**E4915A-04**

# **S E R V I C E                      N O T E**

## **Agilent E4915A Crystal Impedance Meter**

**Warning message of “W69 Out of Srch Range” due to defective A1 main board**

**Figure 1. Spectrum of unlocked source signal**

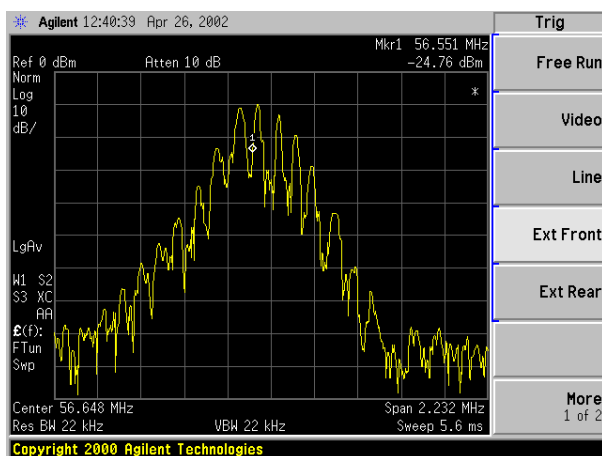
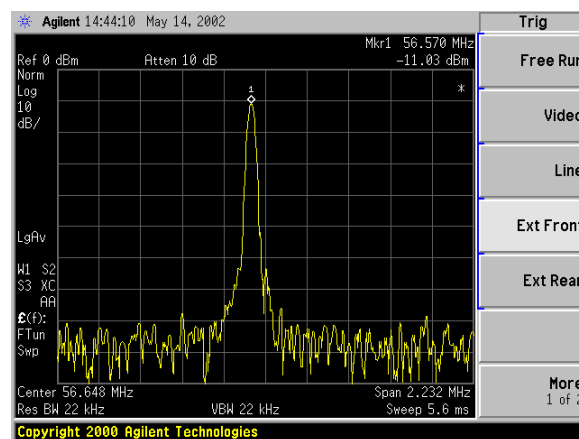
The E4915A equipped with old A1 Main board (P/N E4915-66521) may display a warning message of “W69 Out of Srch Range” when measuring a crystal resonator or filter at frequencies near 55 MHz. As a result, measurement is disabled. The PLL frequency synthesizer of the A1 Main board that fails in phase-lock causes this problem. To verify if the PLL is unlocked, check the source output signal at -5 dBm at 55 MHz by using a spectrum analyzer. Figure 1 shows an example of unlocked source signal on spectrum display compared to normal source signal (Figure 2).

Replace the old A1 board with new A1 board (P/N E4915-69531).
